SERVICE BULLETIN

M-1059

Safety Recall Code 087

Rear Brake Master Cylinder 1996 Sportster, FX Softail, Dyna and FL Softail Models

Figure 1. Sportster Rear Master Cylinder

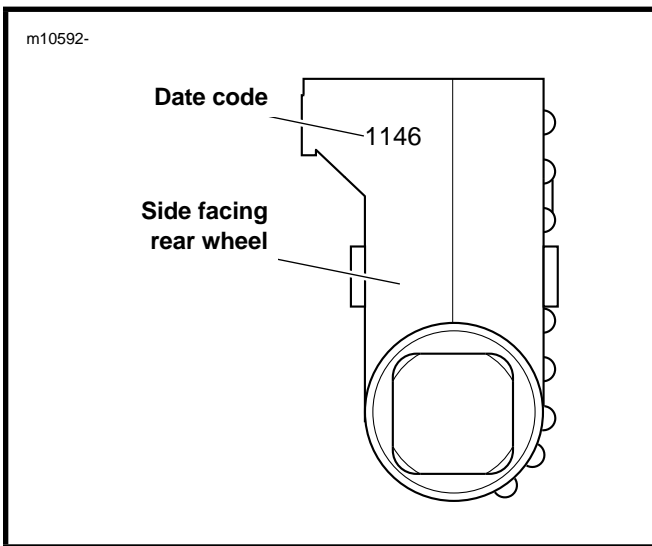
To determine if the vehicle contains an affected rear brake master cylinder, locate the date code. See Table 1 on page 2.

If the date code is "1146", replace the entire assembly with the new assembly supplied to you by Hayes. Follow the replacement procedures in the applicable service manual as listed in Table 1. If the master cylinder does not have a "1146" date code, see INSPECTED VEHICLES below.
